April 13, 2020
Subject: Pavement Milling, HMA Overlay
With Drainage & Safety Improvements
State WIN: 023789.00
Location: **Wayne**
Amendment No. 2

REMOVE page 41, SHEET NUMBER 6 OF 6, TYPICAL SECTIONS, 1 page, and **REPLACE** with the attached, SHEET NUMBER 6A OF 6, TYPICAL SECTIONS.

SIDEWALK WITH CONCRETE
SLIPFORM CURB

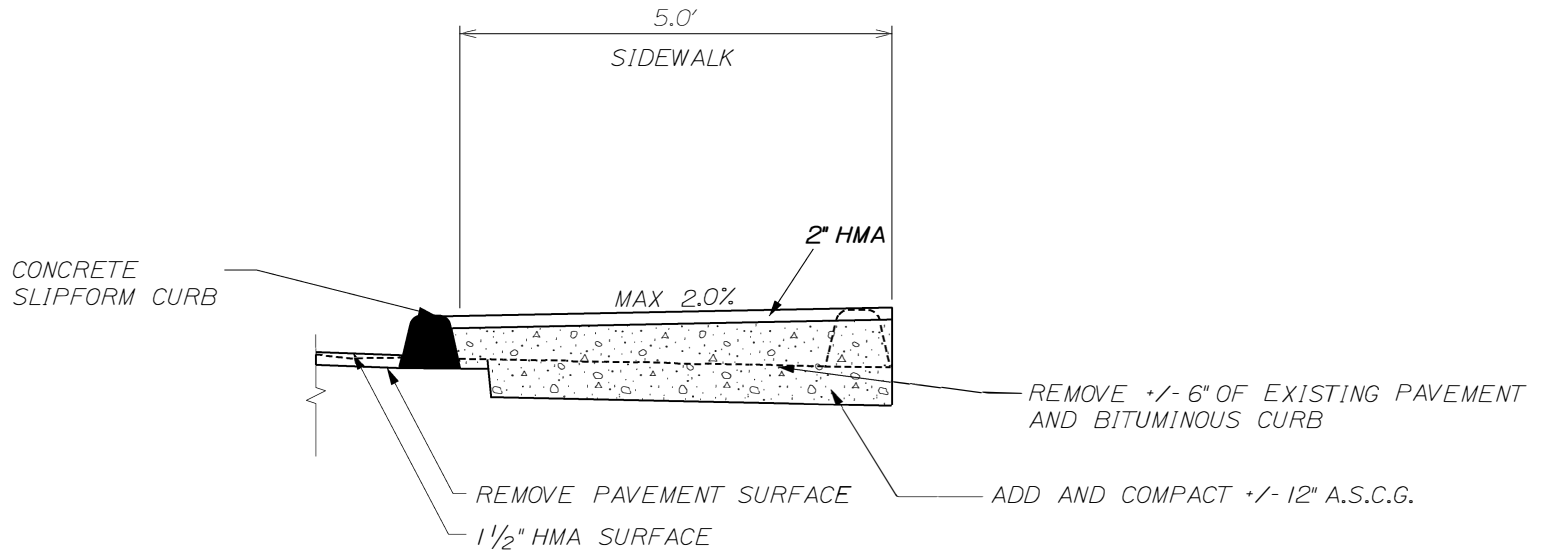
Question: Detail for sidewalk with concrete slipform curb shows the addition of ASCG, could the add an item for this work? If not could the department provide an average depth to be anticipated for in building these sections?

Response: ASCG item will not be added to the bid items. Please see Item 608.45 Construct Sidewalk basis of payment that states: "For construct sidewalk, payment will be for excavation, new aggregate and necessary incidentals to bring the grade to pre-pave grade." The new concrete slipform curb will be placed on milled pavement. Existing pavement below proposed sidewalk will be removed and ASCG will be placed as shown on the revised typical detail. The assumed pavement thickness to be removed under the proposed sidewalk is 6 inches and the average depth of gravel required below the 2" Hot Mix Asphalt is 6 inches. This is consistent with General Note number twelve which states: "All paved walks shall be constructed with 12 inches of aggregate subbase course gravel and 2 inches of hot mix asphalt unless otherwise noted in the Plans or directed by the Resident." Also, see the attached, revised SHEET NUMBER 6A OF 6, TYPICAL SECTIONS.
